Service Bulletin

SEB95-3

FLAP SUPPORT INSPECTION AND ROLLER WASHER INSTALLATION

TITLE FLAP SUPPORT AND ROLLER BEARING INSPECTION/FLAP ROLLER WASHER
INSTALLATION

Figure 1. Flap Support Rib Assembly and Roller Bearing Replacement (Sheet 8)

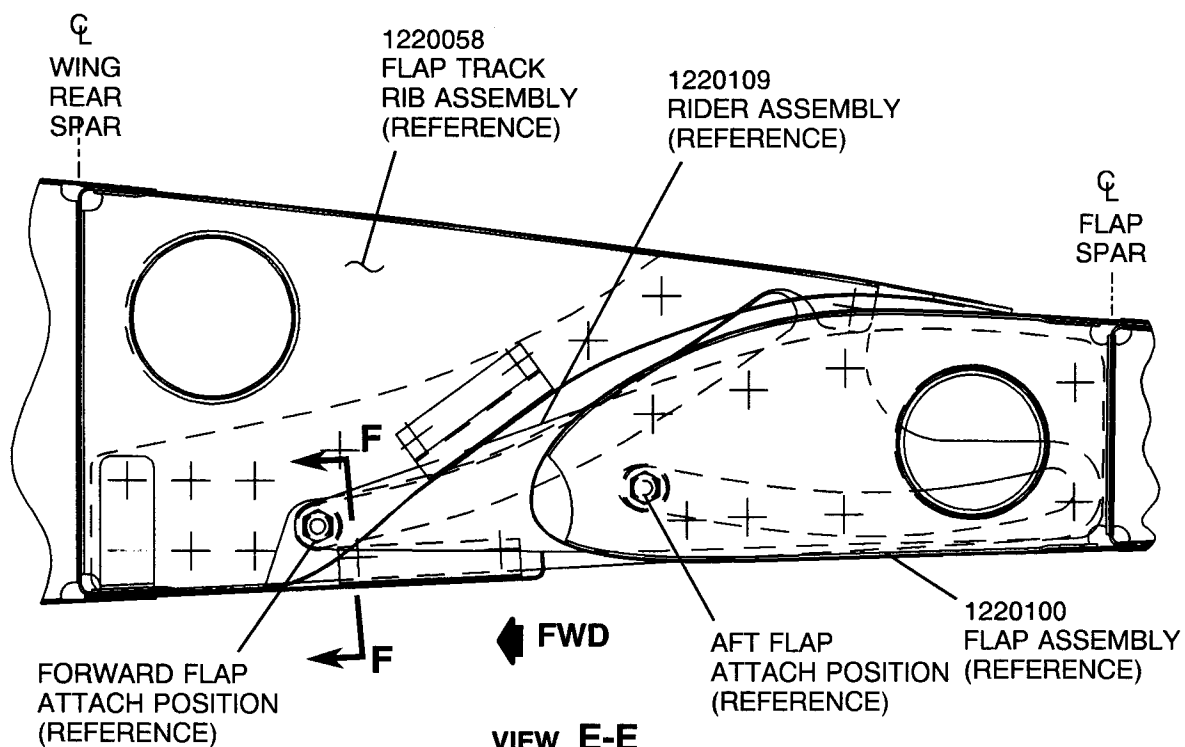
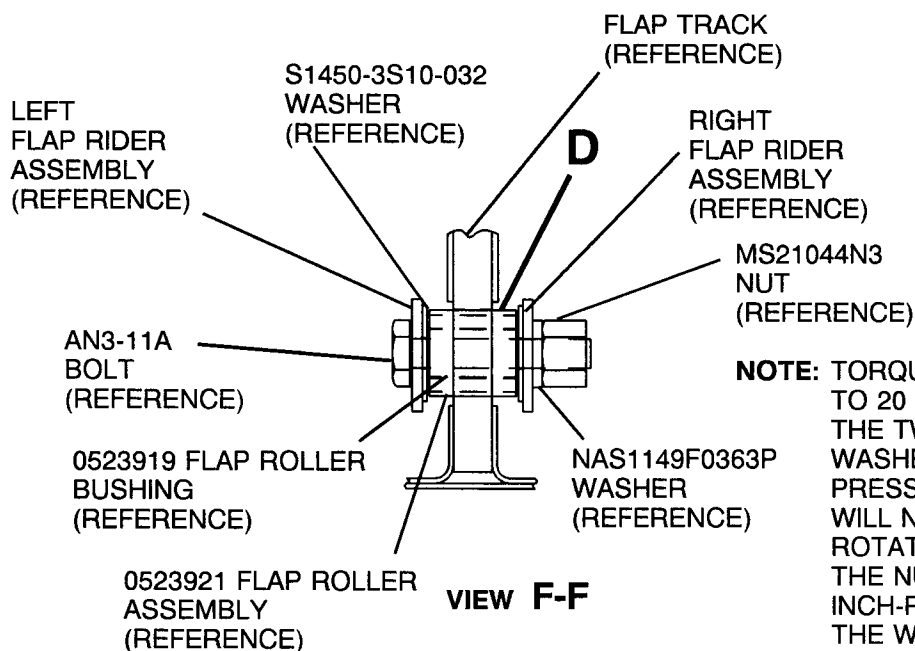
8. Insert the new 0523901-13 left flap support arm in the existing flap support location. Align the aft rivet holes in the flap support arm to the corresponding holes in the flap spar. Secure in position using two temporary metal fasteners. (Refer to Figure 1, Sheet 7, Views A-A, B-B, C-C and Sheet 8, E-E.)

NOTE: DO NOT INSTALL
 S1450-3S10-032 WASHERS ON
 THE AFT ROLLER ASSEMBLY

NOTE: TORQUE THE MS21044N3 NUT
 TO 20 INCH-POUNDS. CHECK
 THE TWO (2) S1450-3S10-032
 WASHERS WITH FINGER
 PRESSURE TO ASSURE THEY
 WILL NOT ROTATE. IF
 ROTATION IS FELT, LOOSEN
 THE NUT, RETORQUE TO 25
 INCH-POUNDS, AND VERIFY
 THE WASHER CANNOT BE
 TURNED WITH FINGER
 PRESSURE

Figure 1. Flap Support Rib Assembly and Roller Bearing Replacement (Sheet 9)

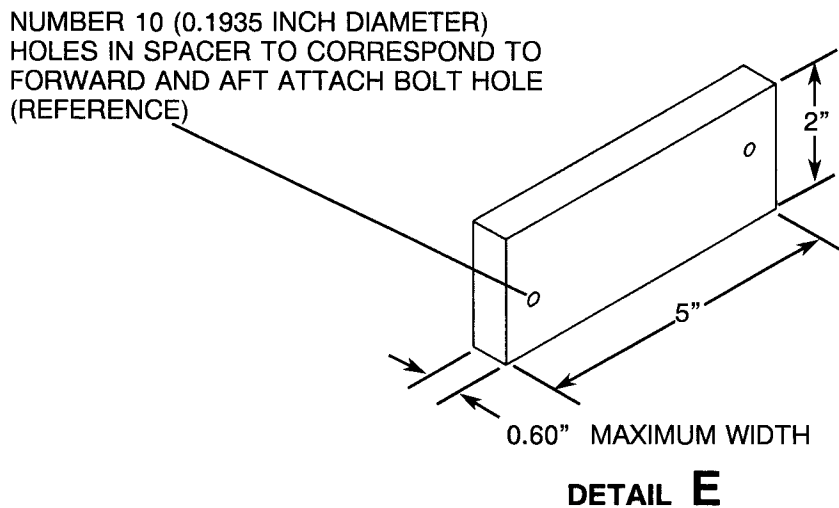
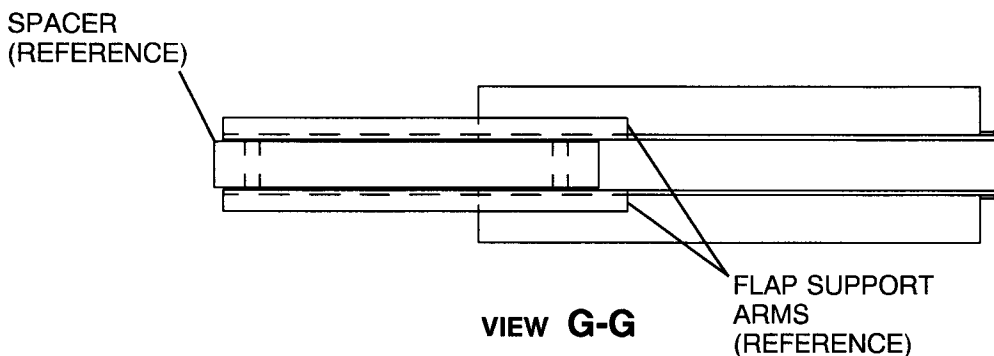
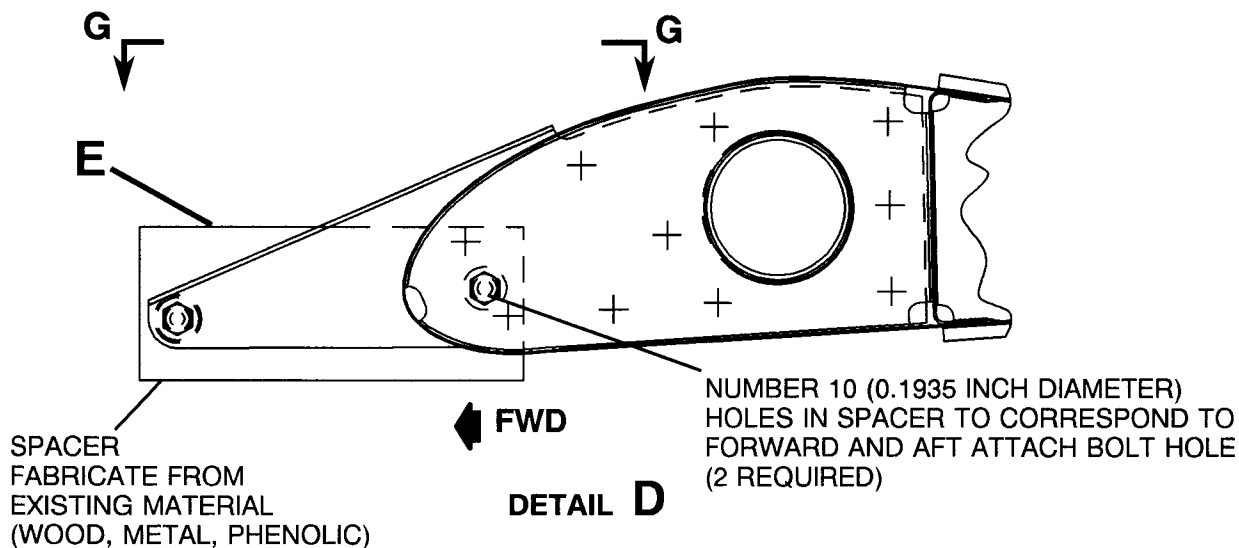
11. Place the spacer between the two flap support arms. Insert an AN3-11A bolt at the forward hole thru the remaining flap support, the new spacer and the new flap support. Insert another AN3-11A bolt thru the aft position in the same manner. Clamp the spacer and supports midpoint between the bolts with a C-clamp. (Refer to Figure 1, Sheet 9, Detail E, View G-G and Detail D.)
